# Addendum Number One (1)

## **New Baseball Stadium Athletic Complex Facility – Phase 2 Louisiana State University Eunice Eunice, LA**

**State of Louisiana  
Office of Facility Planning and Control  
Project No.: 19-605-22-02, F.19002637  
Site Code: 4-01-006**

**Issue Date:** April 10, 2026

**1 ENLARGED PLUMBING PLAN - TEAM CLUBHOUSE**

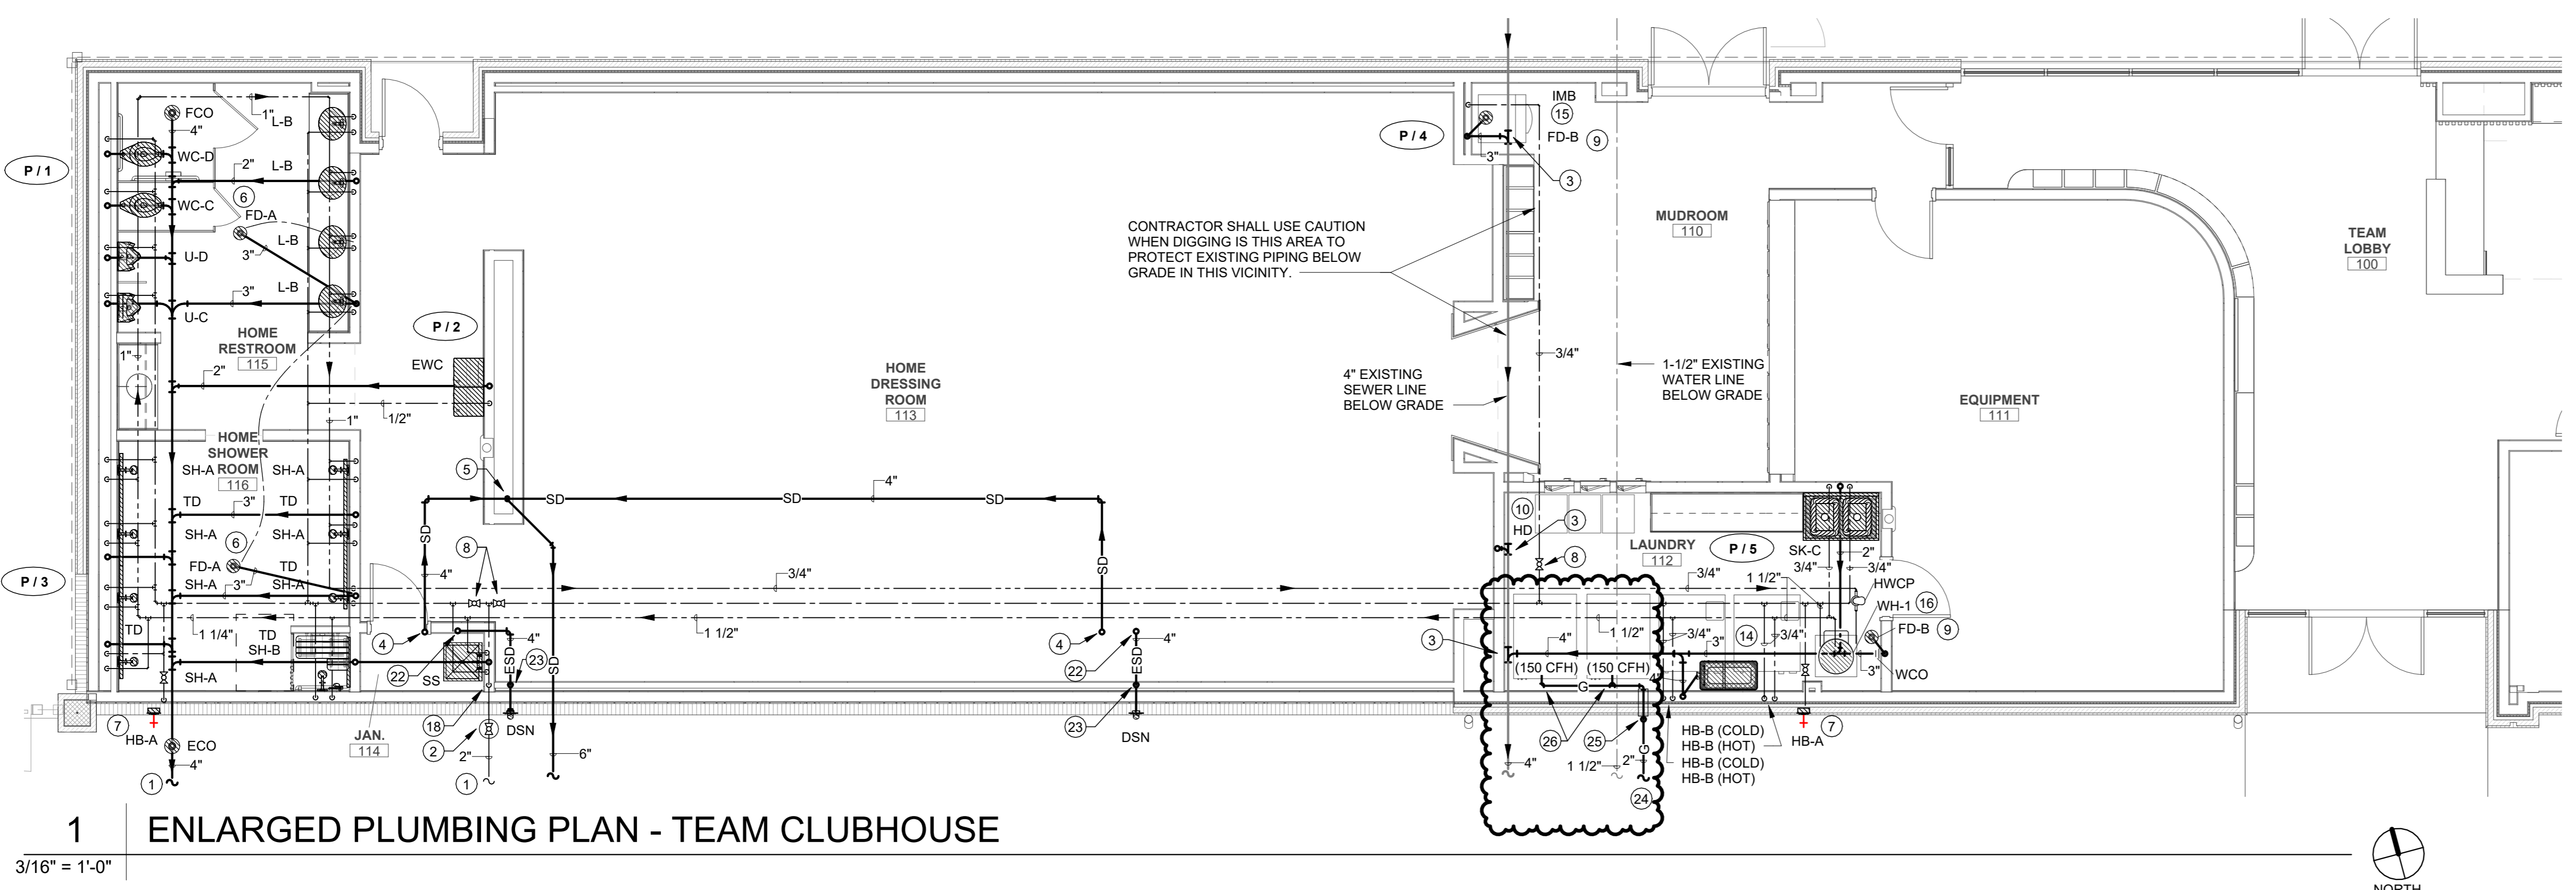
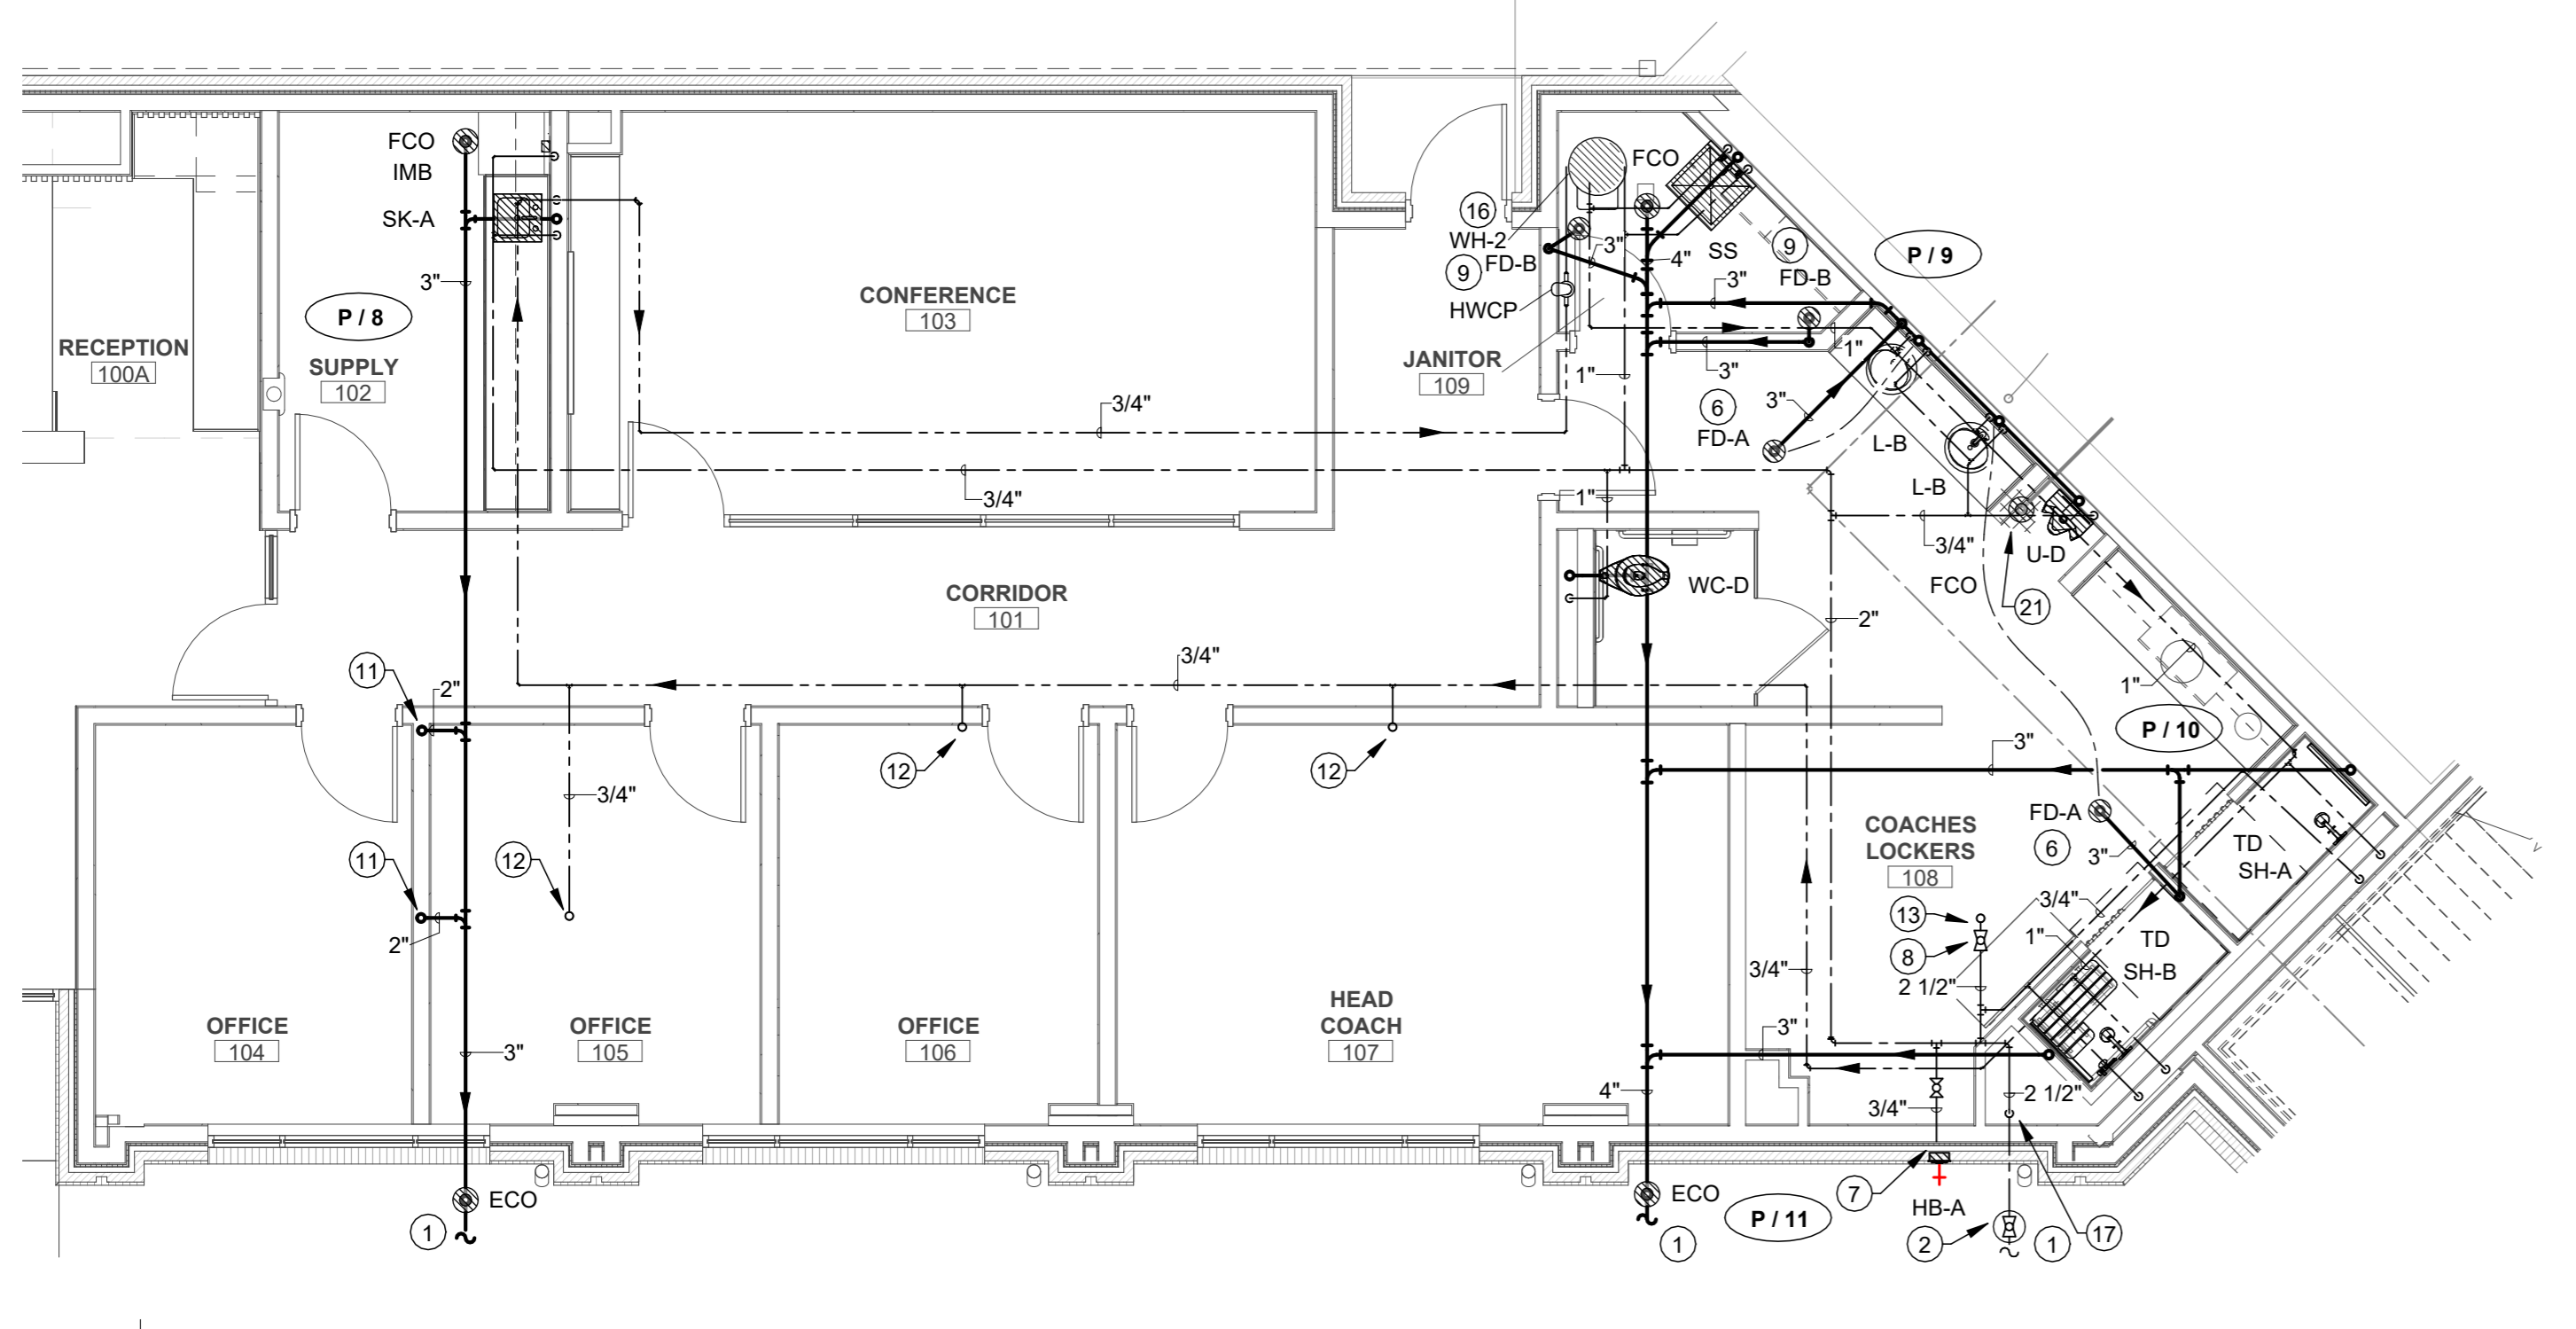
38. P1.01 – Sheet has been added showing extent of gas line
39. P2.21 – Sheet has been revised showing gas line extension and connection to the Team Clubhouse
40. P2.24 – Sheet has been revised showing gas line extension and connection to the Commissary/Kitchen
